**Addendum No. 1**

RE: Contract ID C203658

**Johnston County (I-3318BB)**

Bridges #114 and #116 Over Little River On I-95

SEE SHEET "E1" FOR LEGEND & Δ NOTES

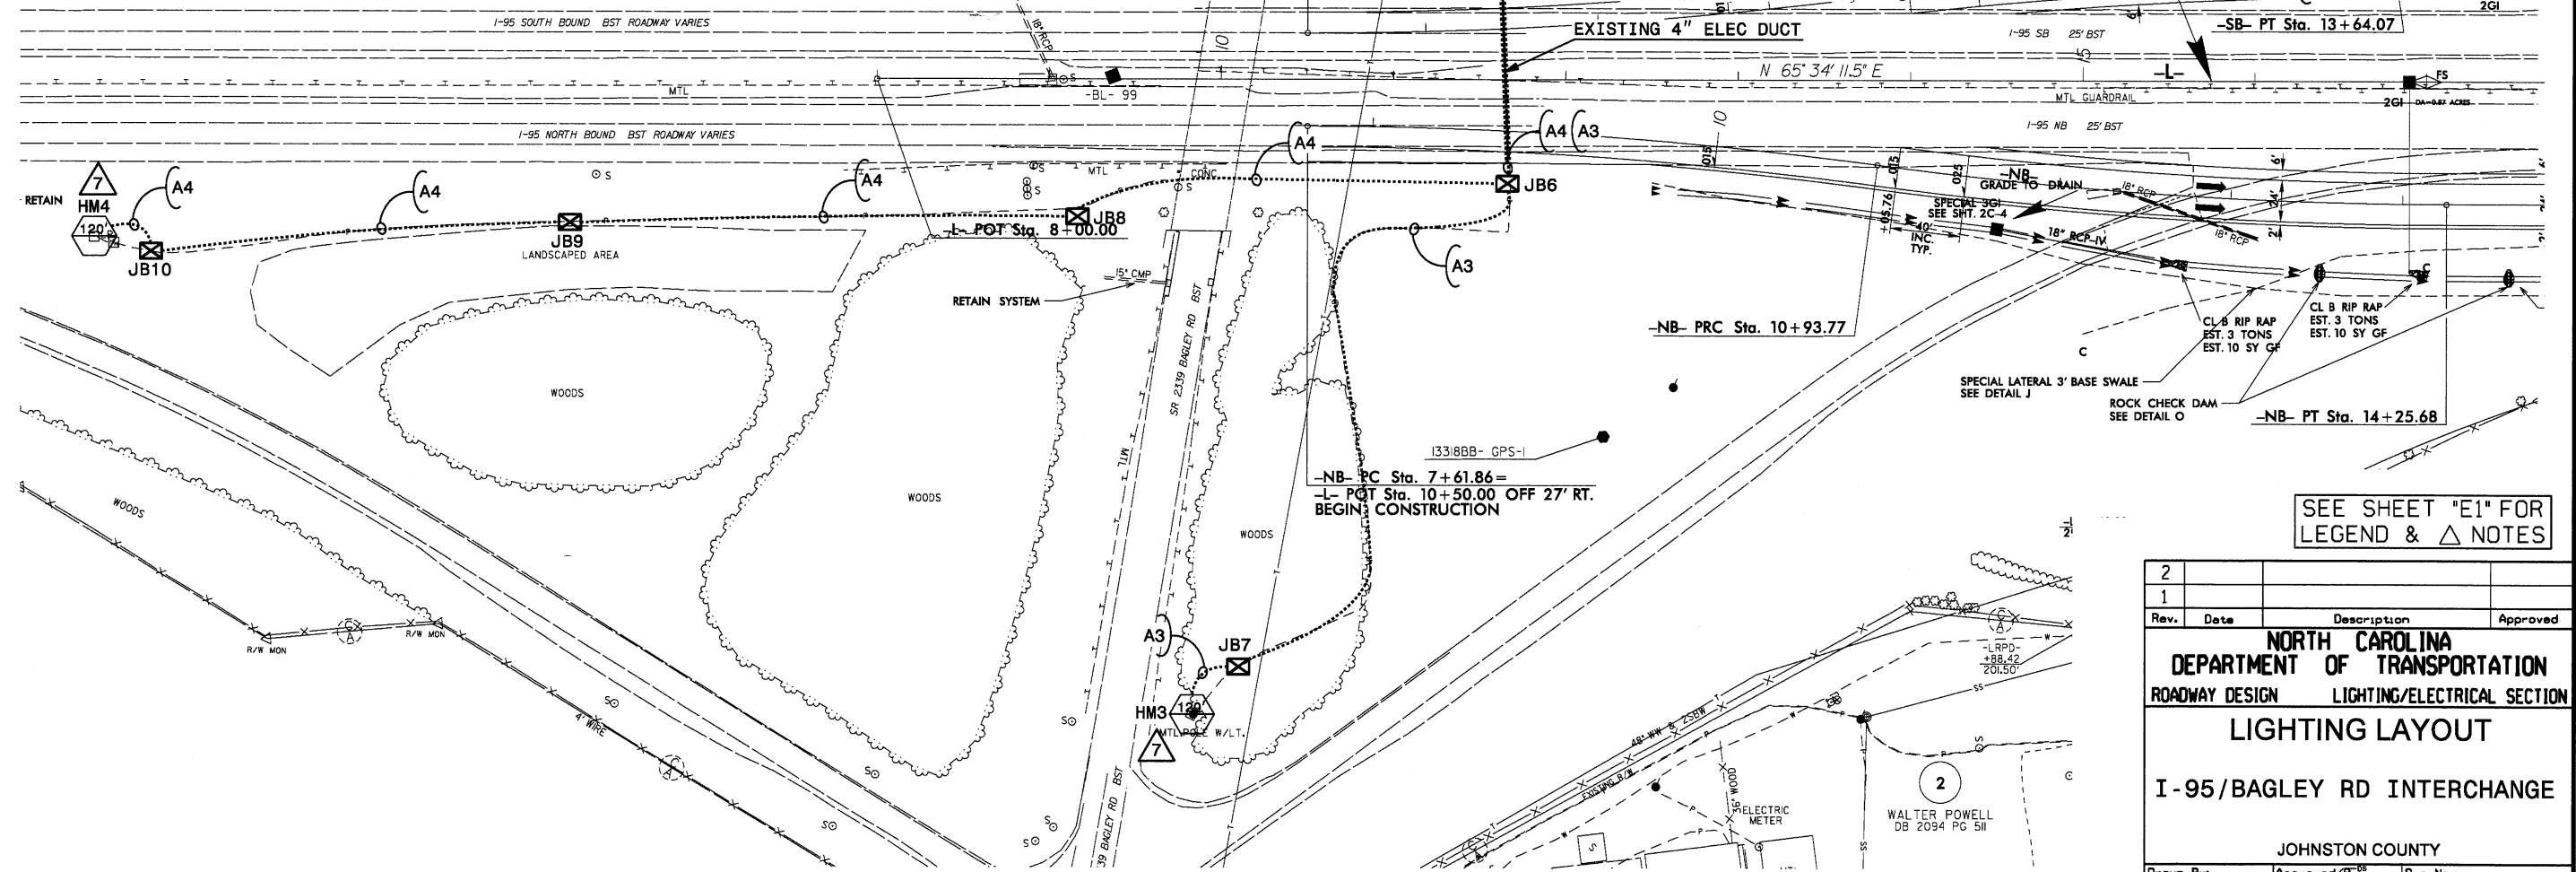
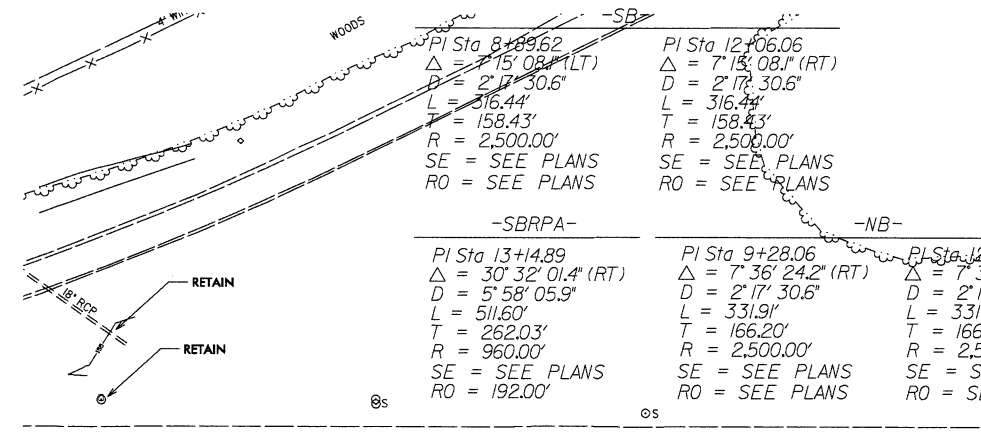
Sheet No.	Revisions
1A	Revised "Index of Sheets" to show the addition of Sheet Nos. E-1 thru E-3 Electrical Plans to the plan set. Please void Sheet No. 1A in your plans and staple the revised Sheet No. 1A thereto.
E-1 thru E-3	Electrical Plans added for some adjustments to existing high mast lights at the Bagley Road/ I-95 interchange. Please staple New Sheet Nos. E-1 thru E-3 after existing Sheet No. PMP-3 in your plans.

- EXISTING 120' HIGH MAST STANDARD. RELOCATE AS SHOWN. ABANDON OR REMOVE RELOCATED POLE FOUNDATION. REMOVE LUMINAIRES ON ALL POLES AND REPLACE WITH 550W MAXIMUM, 53,000 MINIMUM DELIVERED LUMENS, TYPE V LED LUMINAIRES. MAXIMUM BUG RATING 5-0-5.
- EXISTING CONTROL SYSTEM. NO CHANGE REQUIRED.
- EXISTING ELECTRICAL JUNCTION BOX. NO CHANGE REQUIRED UNLESS OTHERWISE NOTED ON THE PLANS.
- PROPOSED ELECTRICAL JUNCTION BOX SEE DETAILS & TABLE B, THIS SHEET
- REFERENCE TO CORRESPONDING NOTE AS NUMBERED
- PROPOSED FEEDER CIRCUIT CONTROL SYSTEM(A), CIRCUIT(1) PLAN SYMBOL (6) SEE TABLE A, THIS SHEET
- EXISTING FEEDER CIRCUIT CONTROL SYSTEM(A), CIRCUIT(1)
